# PARTS & SERVICE NEWS

REF NO. AA03143

**SUBJECT:** REINFORCING A/C CONDENSER OUTLET PIPING

**PURPOSE:** To inform the field of a reliability improvement for air conditioner systems.

FIGURE 1. OUTLET TUBE

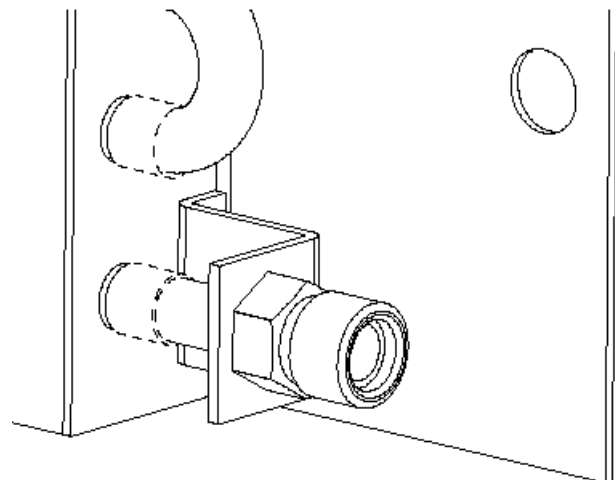
Some trucks in operation may experience damage to the outlet tube on air conditioning system condensers (PB9510). Normal truck operation and vibration can sometimes cause damage to this tube due to lack of support. Figure 1 illustrates the current outlet tube arrangement.

A field improvement has been developed that entails welding a locally fabricated support gusset to the existing support. The addition of the gusset reduces the possibility of this damage occurring and increases the life of the condenser, resulting in less downtime.

FIGURE 2. GUSSET SPECIFICATIONS

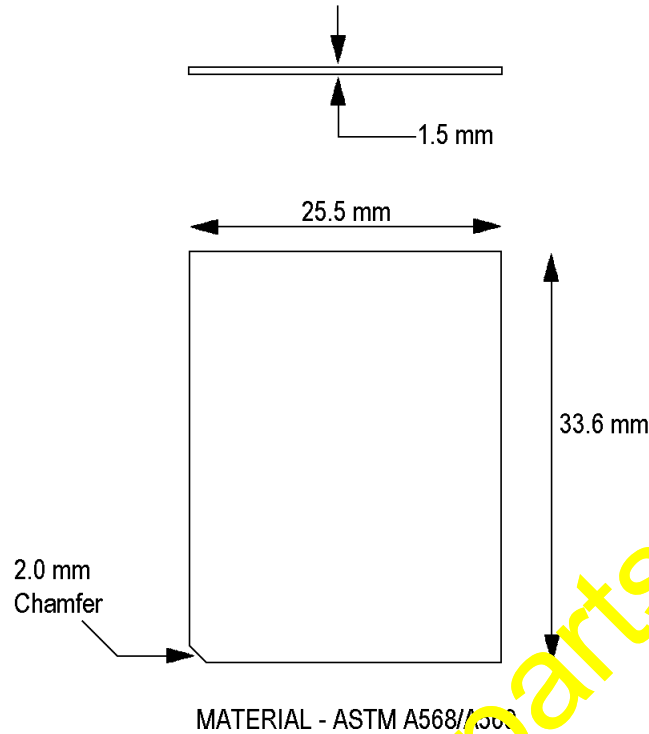
Refer to Figure 2 for dimensions for fabricating the gusset. Refer to Figure 3 for welding specifications and installation details.
